Subject: Replacement of Oil-Cooler Snap-Ring (MD3060 or RDS3000 Transmission)

Bulletin: C0004

Campaign #: A4780

This Service Campaign involves the replacement of the snap-ring and the installation of the grommet located on the transmission oil-cooler inlet and outlet lines.

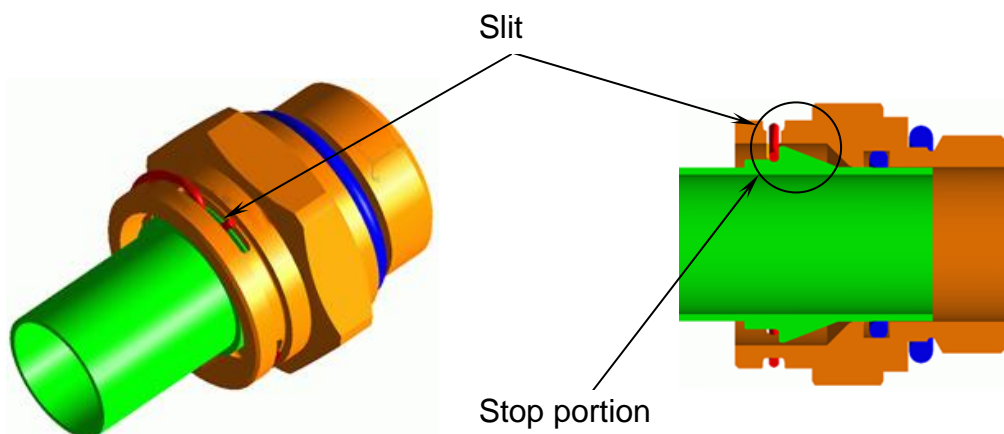
5. Insert the snap-ring into the slits of oil cooler nut.

6. Gently pull on the line to ensure the snap-ring and lines are properly seated.

⚠ As shown in Figure below, check that the snap-ring was securely inserted into the slit.

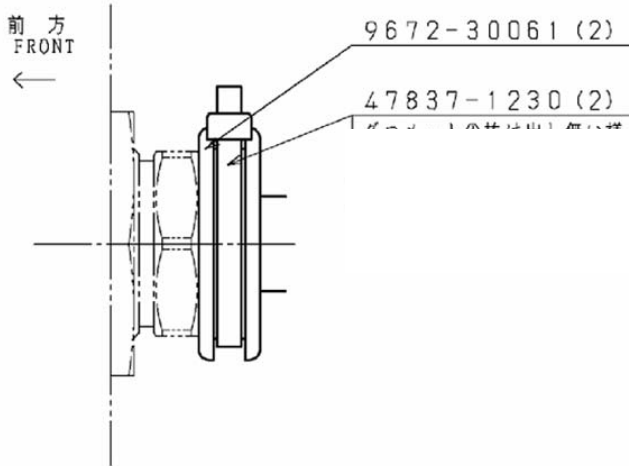
7. Install the new grommet onto the nut, covering the snap-ring.

12. Secure the grommet with the tie-wrap, tight enough to prevent the grommet from coming off.

Make sure to secure the grommet over the snap-ring by pushing it forward.
